## ZONING COMMITTEE STAFF REPORT

FILE #19-088-143 (PC)  
FILE #19-075-478 (SPR)

1. **APPLICANT:** Rohn Industries **HEARING DATE:** 10/24/2019
  2. **TYPE OF APPLICATION:** Site Plan Review
  3. **LOCATION:** 2495 Kasota Ave
  4. **PIN & LEGAL DESCRIPTION:** 202923330007 Auditor's Subdivision No. 64 Subj To Kasota Ave Part N Of Cl Of Sd Ave Of Lot 2
  5. **PLANNING DISTRICT:** 12 – St. Anthony Park Community Council **PRESENT ZONING:** I1
  6. **ZONING CODE REFERENCE:** §61.402 – Site plan review by the Planning Commission
  7. **STAFF REPORT DATE:** 10/18/19 **BY:** Amanda Smith
  8. **DATE RECEIVED:** 8-9-19 **DEADLINE FOR ACTION:** 12-7-2019 (Extension letter sent)
- 
-

A. **PURPOSE:** Site Plan Review for improvement of an existing vacant lot proposed for outdoor storage.

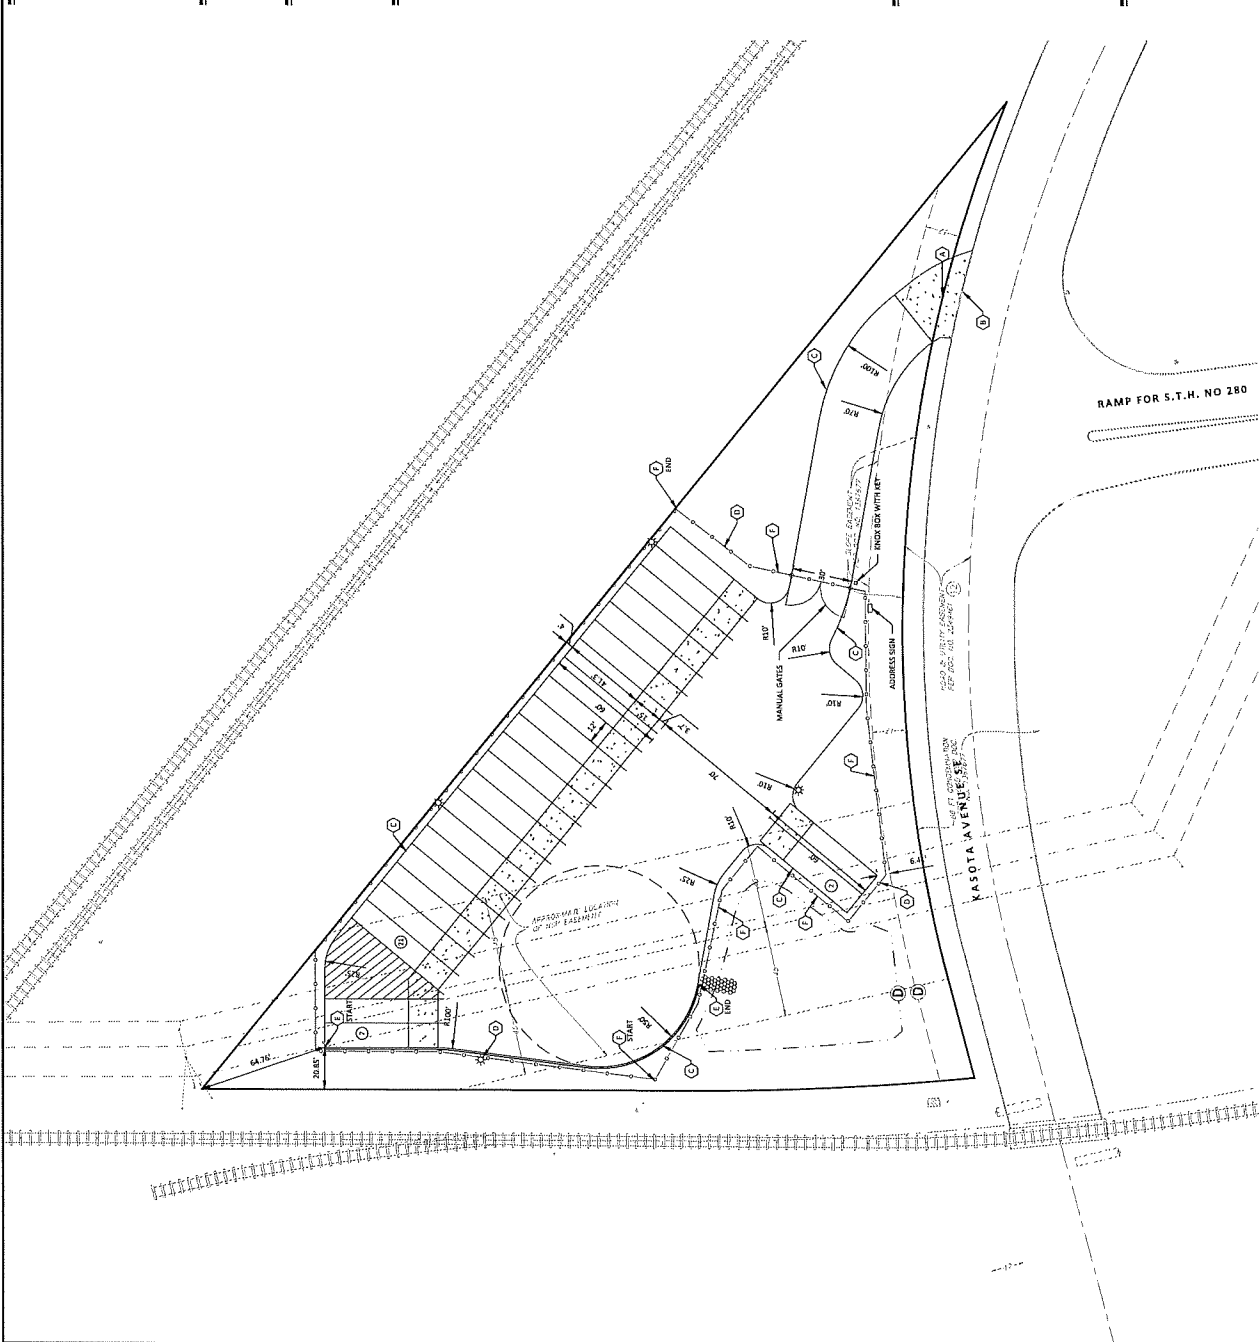
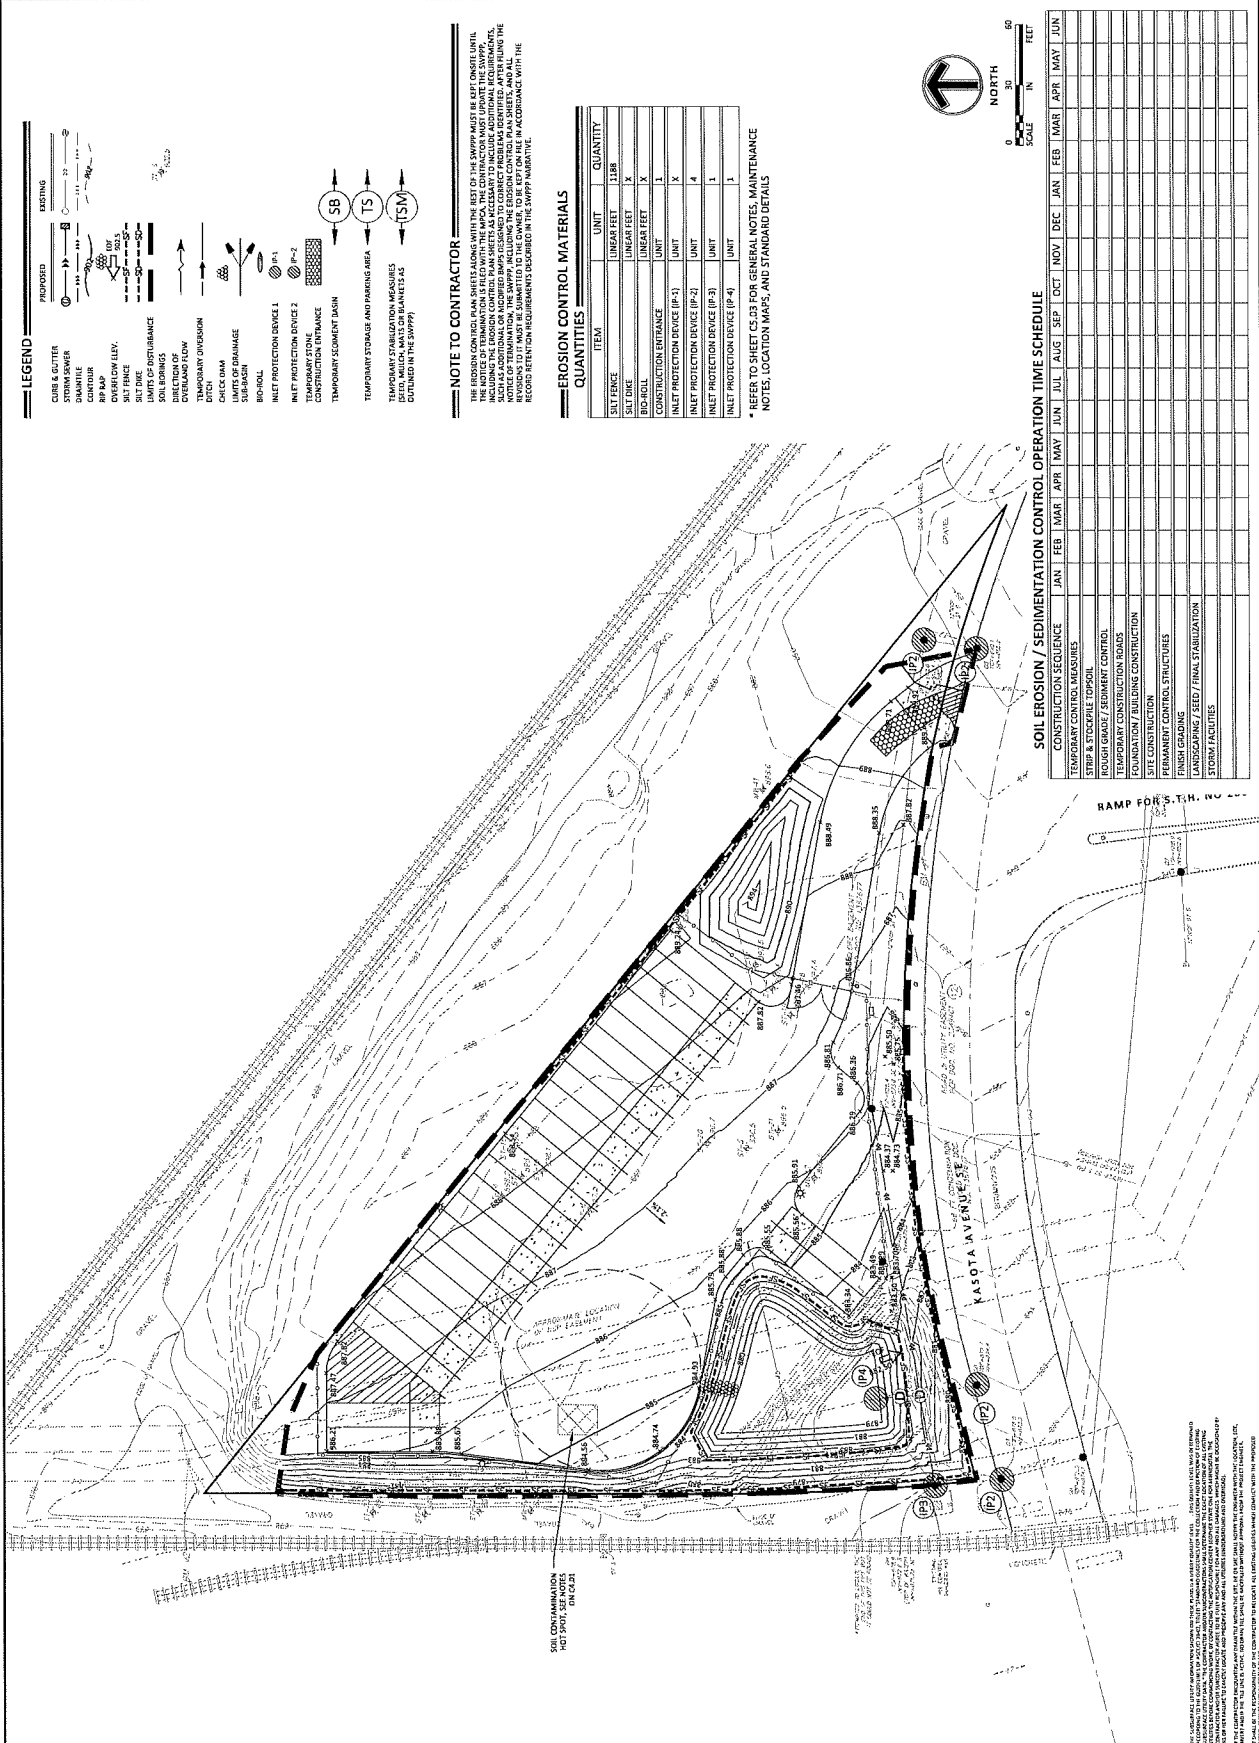
- Outdoor storage shall be fenced or walled. Outdoor storage which abuts a thoroughfare shall be behind a six-foot-high obscuring fence. *Kasota Avenue is classified as a thoroughfare. In addition to the proposed landscaping, update the site plan to include a six-foot high obscuring fence, and include a detail.*

- c) Add the street names to the plan sheets.
- d) Please use the City Standard Detail plate 1206D for driveways.
- e) Update the Site Plan with the following notes:

- b) Sidewalk grades must be carried across driveways.
- c) Update the Site Plan with the following notes:
  - CONSTRUCTION IN RIGHT OF WAY: All work on curbs, driveways, and sidewalks within the public right of way must be done to City Standards and Specifications by a contractor licensed to work in the City right-of-way under a permit from Public Works Sidewalk Section (651-266-6108). Sidewalk grades must be carried across driveways.

**Response:** Privacy slat inserts (EZ Slats by Privacy Link) will be installed in the fence adjacent to Kasota Ave to screen the trailer storage from Kasota Ave. See C3.01 for location and C9.01 for a detail.

**Response:** There will be no proposed business sign at this site. An address sign will be installed near the gate, see C3.01.

**Response:** Detail plate 1206 has been added to C9.01.

**Response:** *Theses notes have been added to sheet C3.01.*

**Response:** Address sign and key box added near the front gate, see sheet C3.01.

**Response:** Permit requirements are included on C3.01.

**Rohn Site R/W lines and turnbacks**

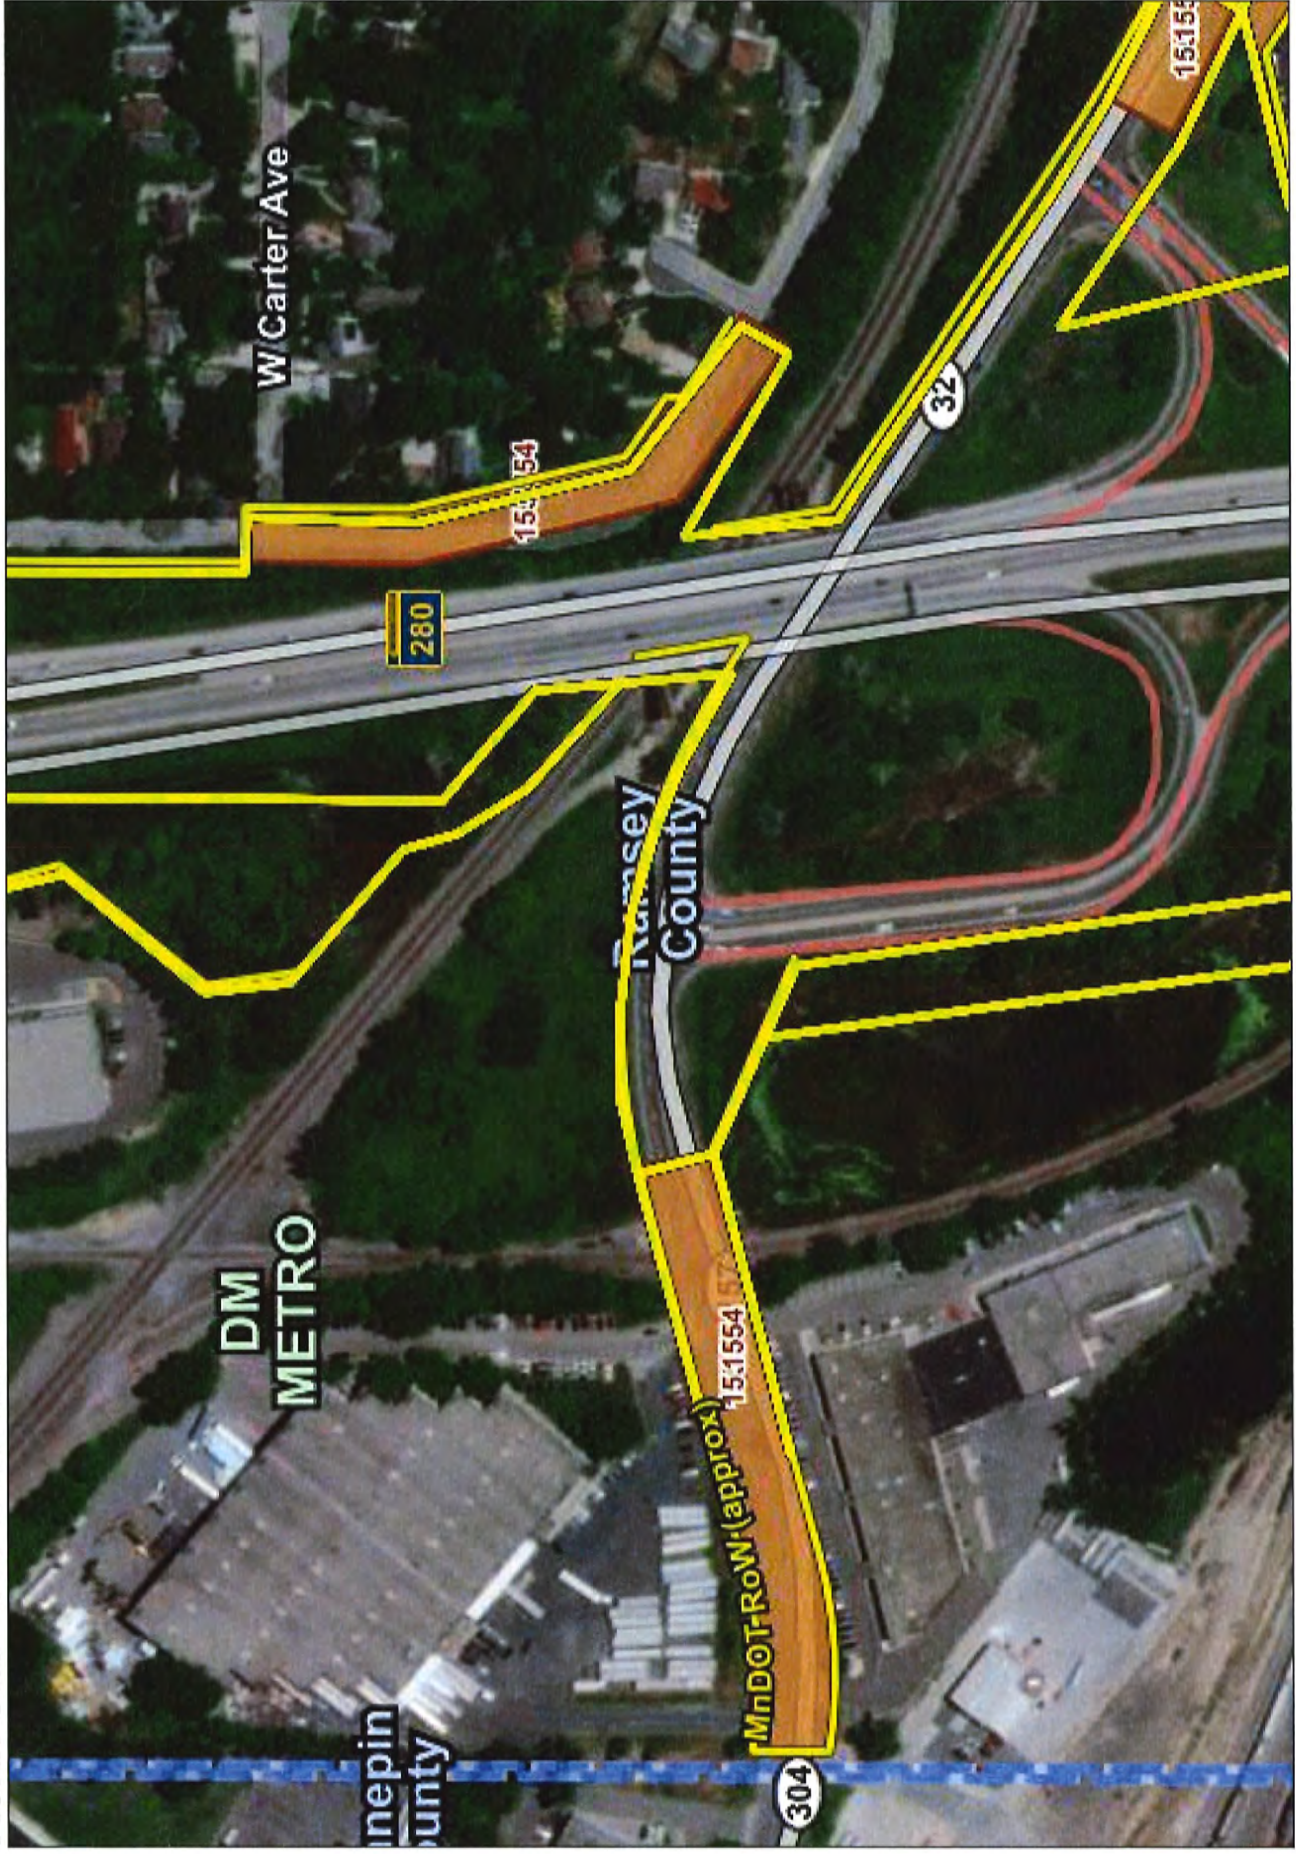
1. On 10/16/19 city staff were notified by MnDOT staff that the proposed driveway location at Energy Park Drive is MnDOT right of way, and therefore will require a MnDOT access permit. Please reference attached graphic provided by MnDOT that shows MnDOT right-of-way and turnback's at the site and vicinity. Ramsey County data available to City staff does not show this area to be MnDOT right-of-way.
